21 November 2017

SECTION 96(1A) - MODIFICATION APPLICATION TO SSD 6840 (MOD 5) ST VINCENT'S PRIVATE HOSPITAL SYDNEY

The modification relates to minor façade amendments, the installation of three building identification signs, and minor demolition works.

Figure 4 - The proposed awning fascia sign

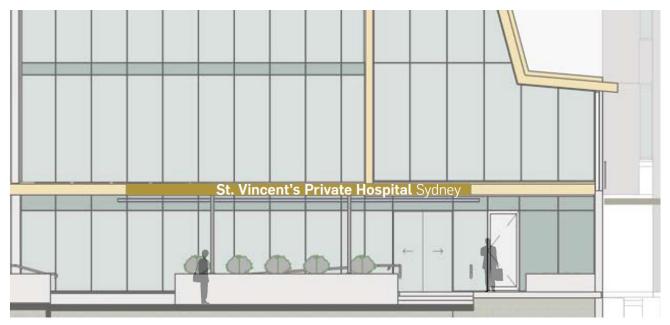
The third sign proposed is an awning fascia-type sign, to be fixed to the canopy which protrudes from the northern elevation, over the hospital forecourt entry to the building. It is noted that this level is referred to as Level 3, however due to the geography of the site and design of the building, this level appears as being ground level, and is accessed as such.

The sign consists of individual lettering, made of Perspex. The lettering will be an opal (white) colour, while the returns will be painted the same gold colour as will be used on the canopy. The sign in internally illuminated using white LED lighting, and is designed to have a visibility range of at maximum approximately 100 m. The proposed sign is shown in **Figure 4** below

Figure 8 – Level 11 plan, as approved under SSD6840 MOD 1. The approximate areas of demolition works proposed in this modification are noted by the red squares.

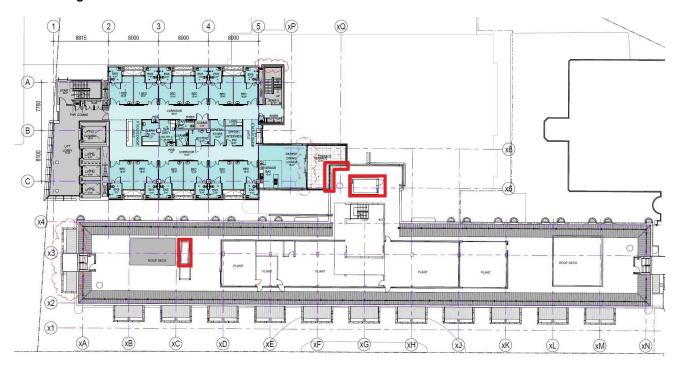
- Partial removal of a section of parapet at the rear eastern corner of the building, to enable construction of an adjoining terrace;
- Removal of a disused lift motor room at the rear of the building of disused plant rooms to allow service installation;
- Removal of a store room for the building maintenance access hoist, which is being decommissioned. Removal of this store room is also to allow service installation.

As mentioned, the partial removal of a section of the parapet is to allow for the construction of the new terrace slab. This terrace is for the adjoining East Wing Building, approved under SSD 6840. This, and the other areas to be demolished are shown in **Figure 8** below.
